## ORIGINATION FORM

Proposed Revisions to a Standard Plans Index  
(Please provide all information — Incomplete forms will be returned)

Index Number: 102-615  
Sheet Number (s): 1 and 4 of 5  
Index Title: Multilane Roadway, Intersection Work

LAST REVISION	REVISION	DESCRIPTION:	 FY 2021-22 STANDARD PLANS	MULTILANE ROADWAY, INTERSECTION WORK	INDEX 102-615	SHEET 1 of 5
11/01/20

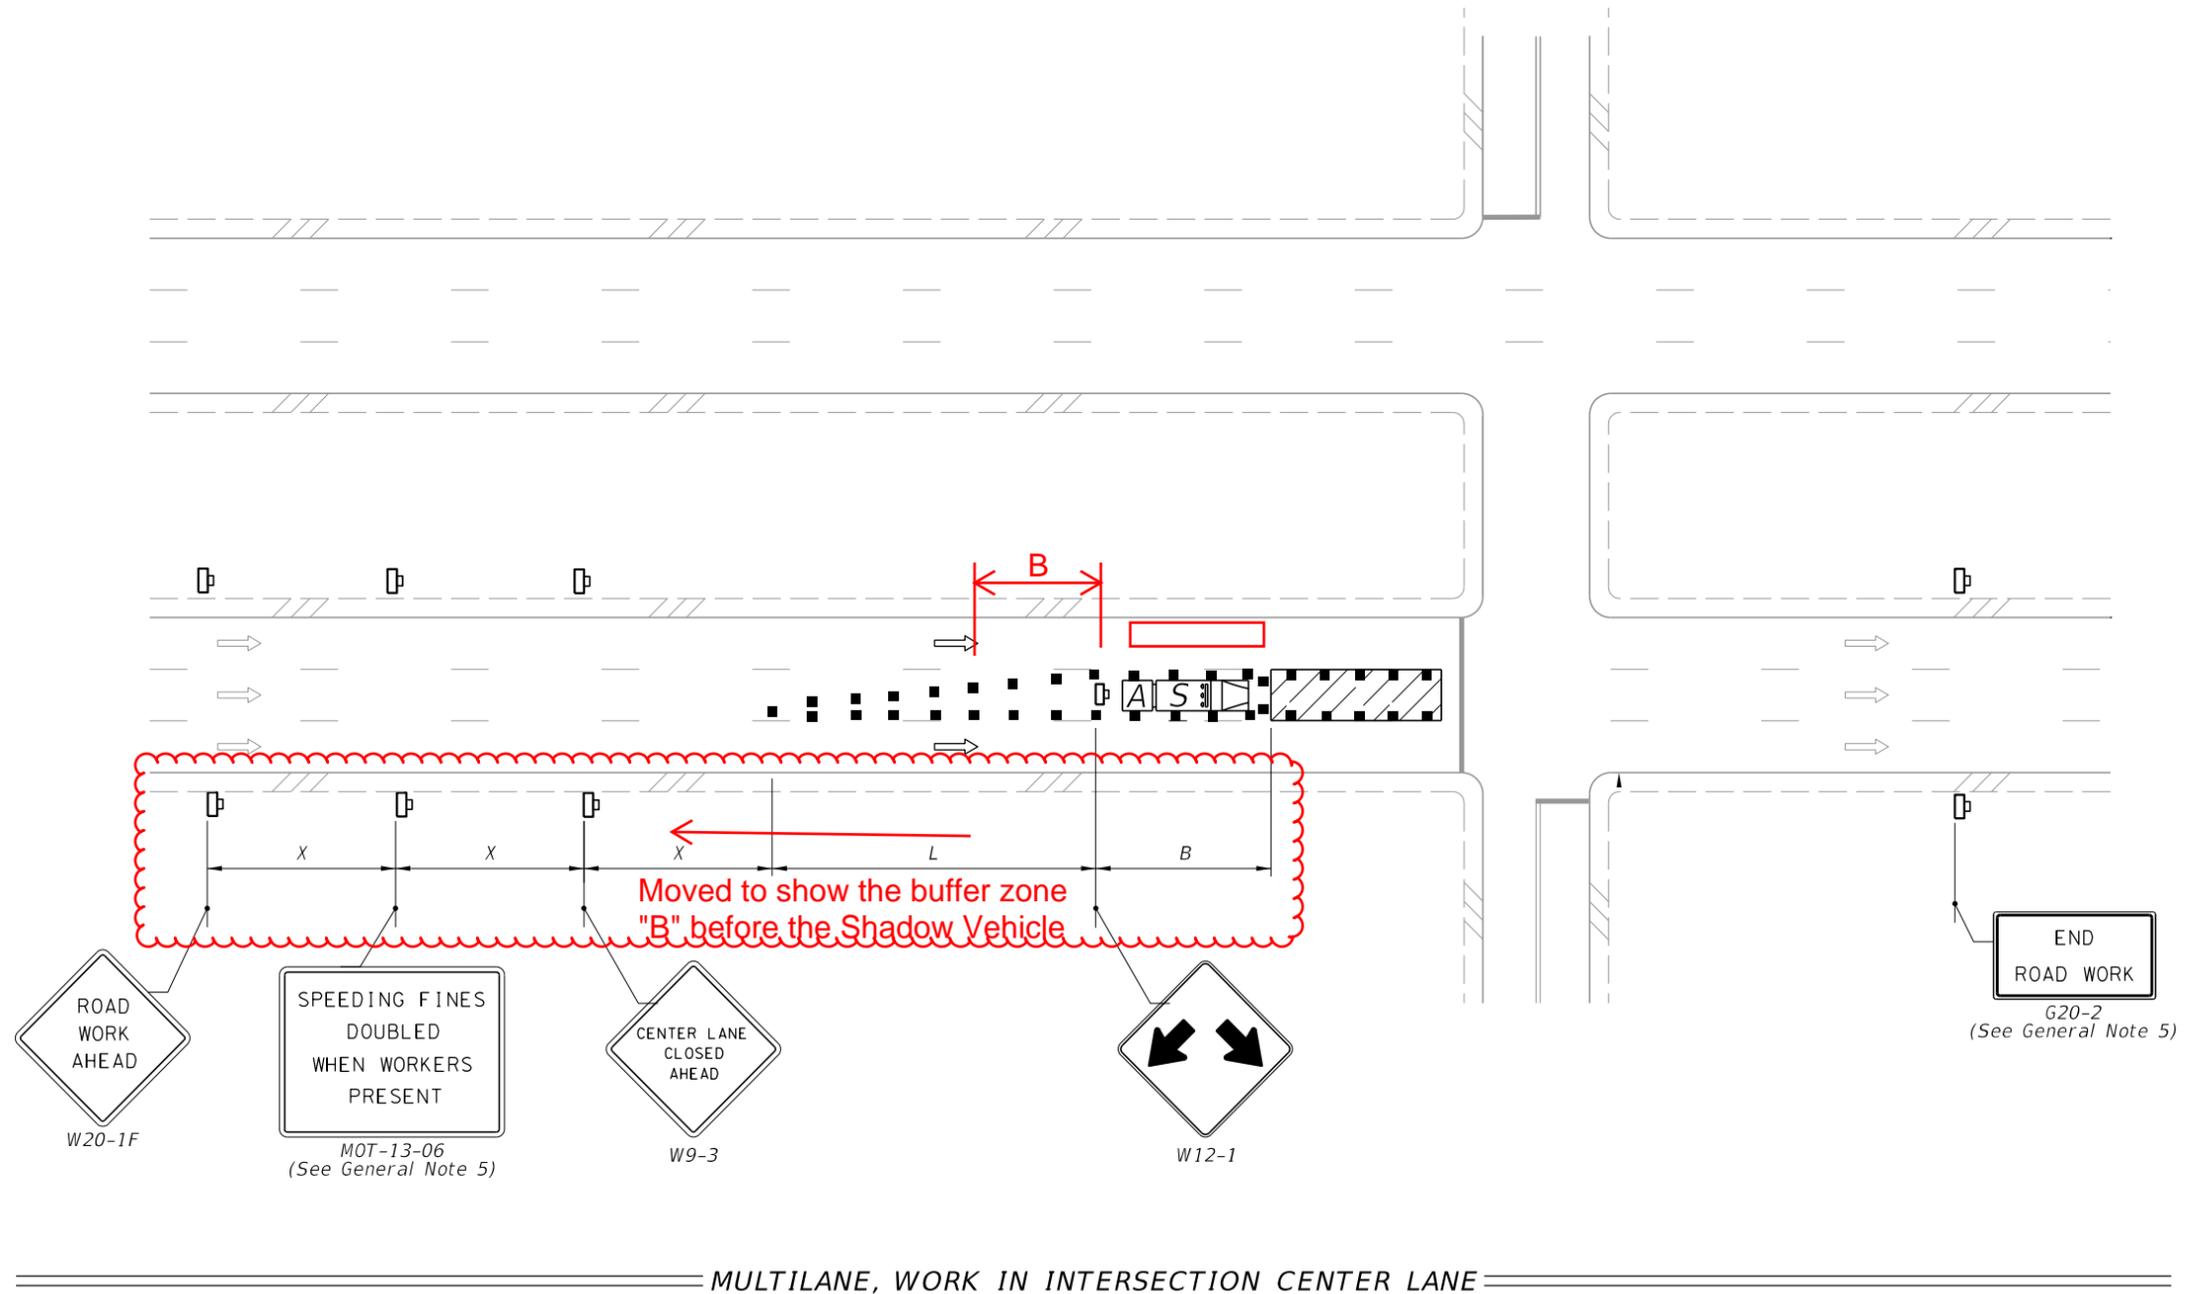
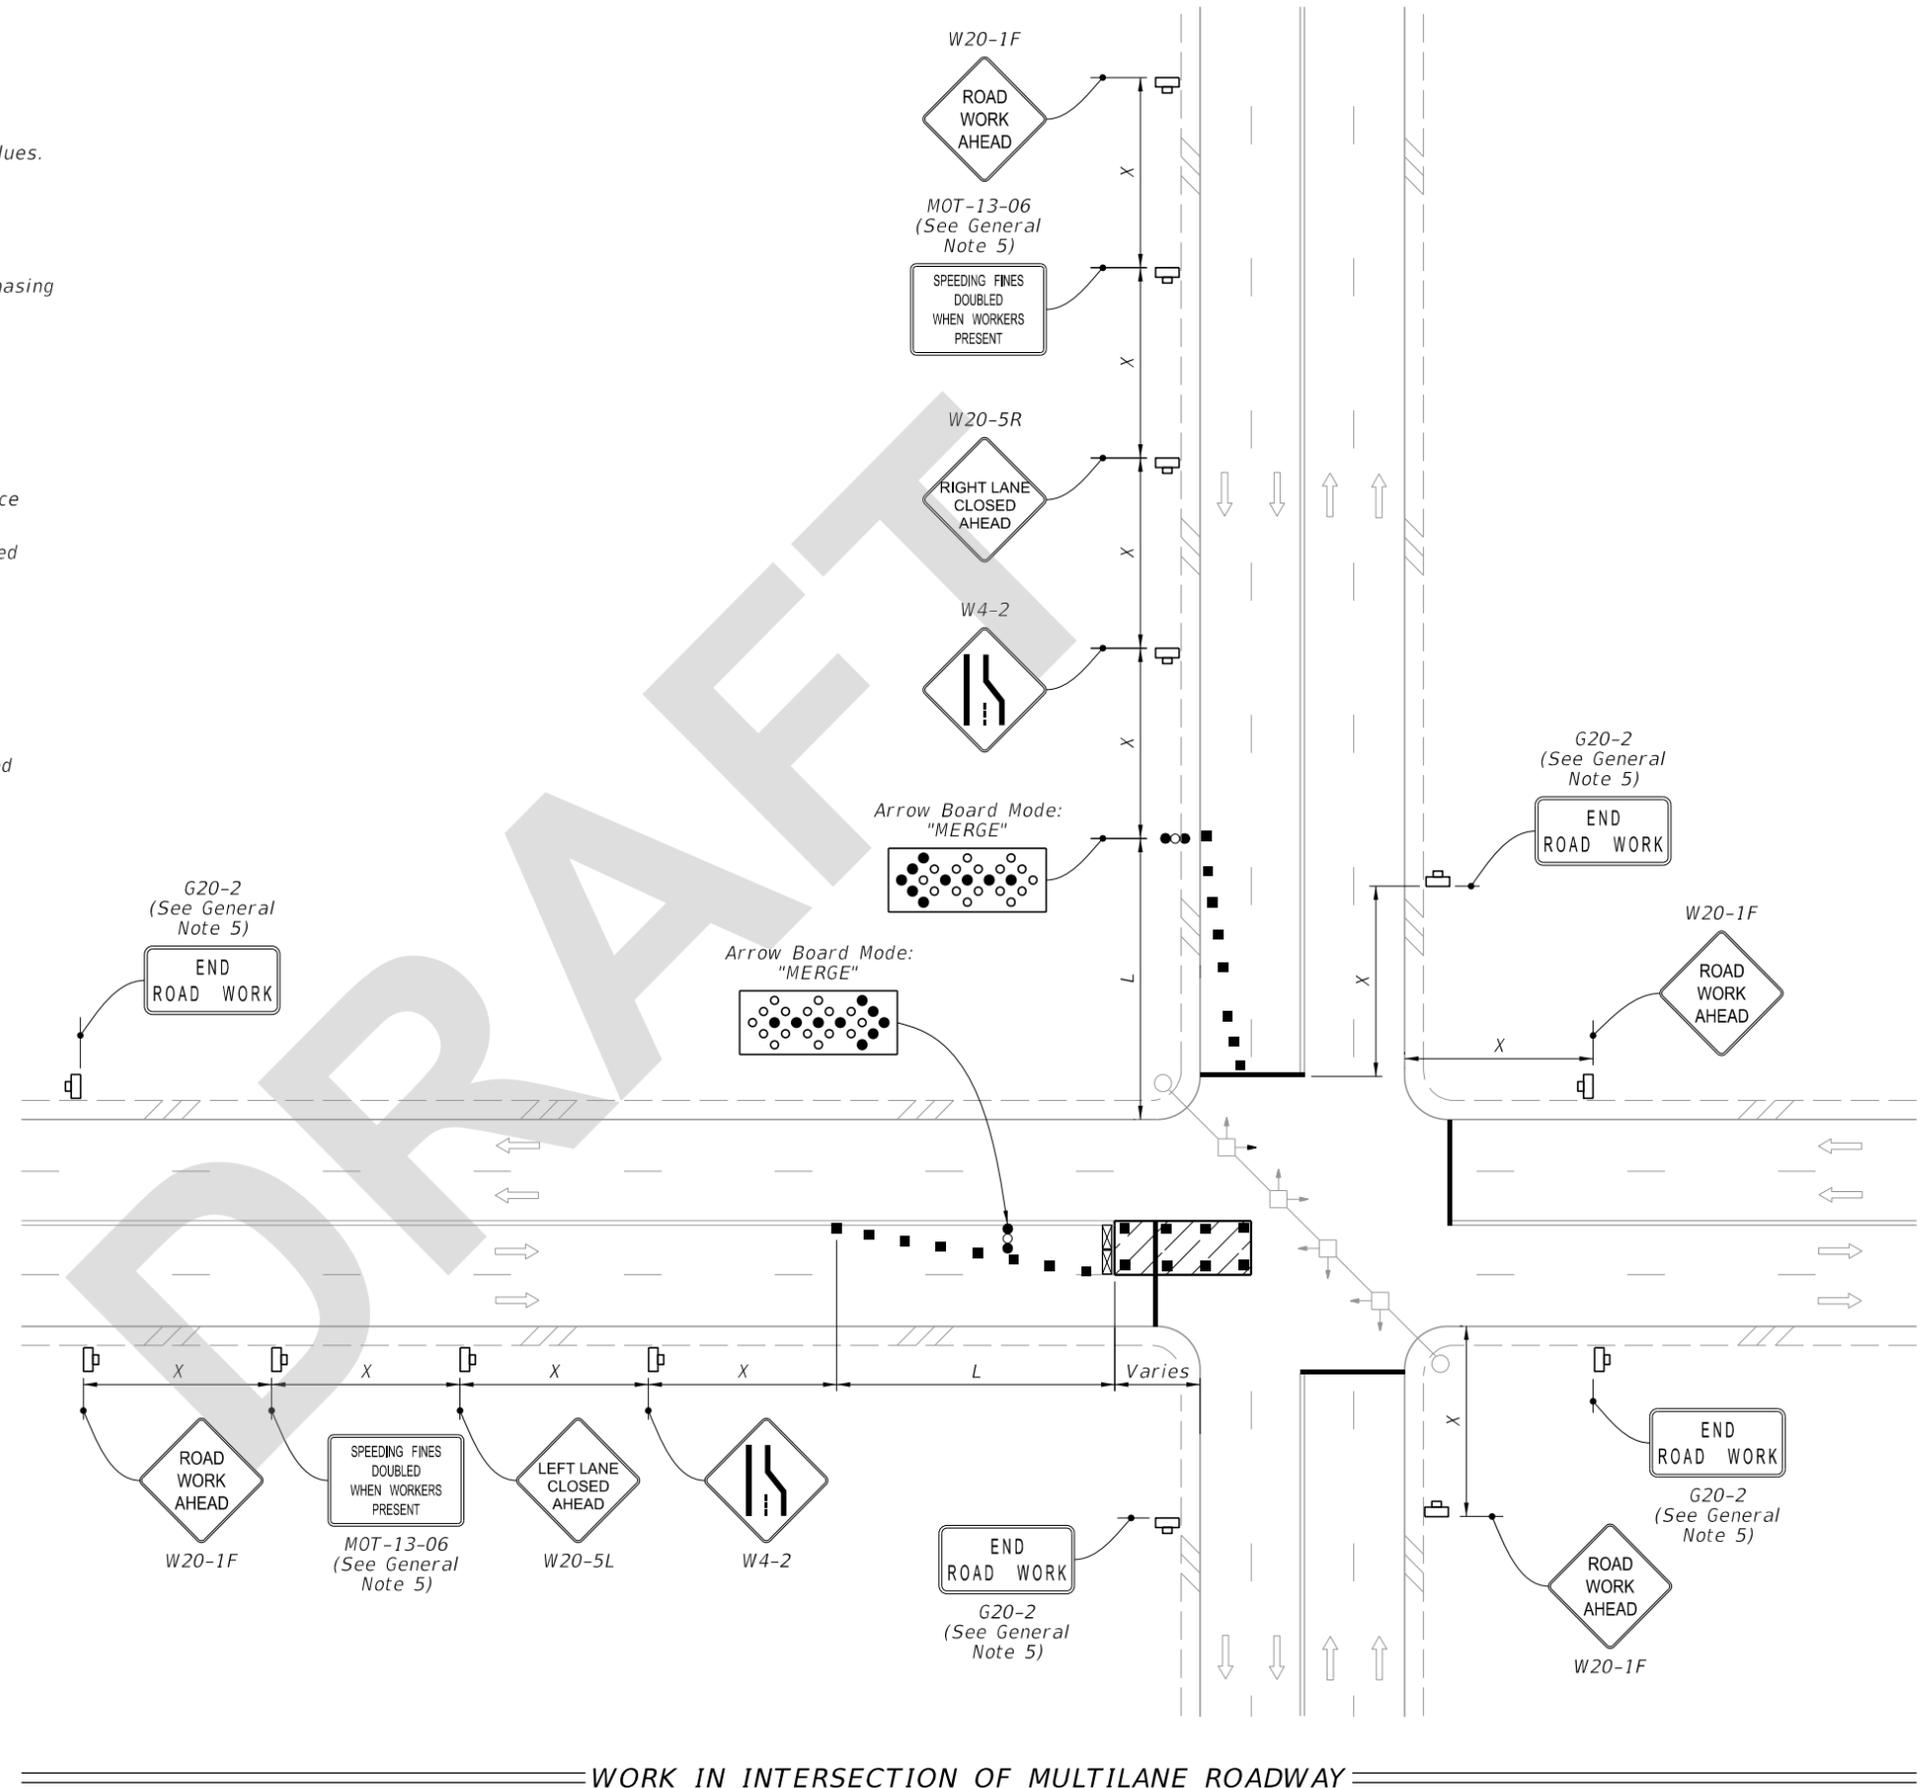
Sheet 1: Changed Note 5 - "work zone" to "work operation"; Changed Note 8 - "ridable shoulder" to "4' or greater paved Shoulder".

The duration provisions of the index are intended to apply to the length time needed to perform the specific temporary traffic control work "operation" shown, which is independent of the duration of an overall construction project. The term "Work Zone" is being replaced with "Work Operation" to clarify the intent.

4. Use temporary "STOP" sign (R1-1) where the existing stop bar is more than 30' from the taper, remove or cover existing sign.
5. The "Speeding Fines Doubled When Workers Present" sign (MOT-13-06) and "End Road Work" Sign (G20-2), along with associated Work Zone Sign Distances, may be omitted when the work zone will be in place for 24 hours or less. Additionally, arrow boards may be omitted when the work zone will be in place for 60 minutes or less and the speed limit is 45 mph or less. **CHANGED TO: operation**

6. If the work area extends across a crosswalk, close the crosswalk in accordance with Index 102-660.
7. Dual signs are required for divided roadways. **CHANGED TO: 4' or greater paved**

4. Use temporary "STOP" sign (R1-1) where the existing stop bar is more than 30' from the taper, remove or cover existing sign.
5. The "Speeding Fines Doubled When Workers Present" sign (MOT-13-06) and "End Road Work" Sign (G20-2), along with associated Work Zone Sign Distances, may be omitted when the work operation will be in place for 24 hours or less. Additionally, arrow boards may be omitted when the work operation will be in place for 60 minutes or less and the speed limit is 45 mph or less.

6. If the work area extends across a crosswalk, close the crosswalk in accordance with Index 102-660.
7. Dual signs are required for divided roadways.
8. If the work encroaches on a marked bicycle lane or 4' or greater paved shoulder, close the lane or shoulder in accordance with the Plans.
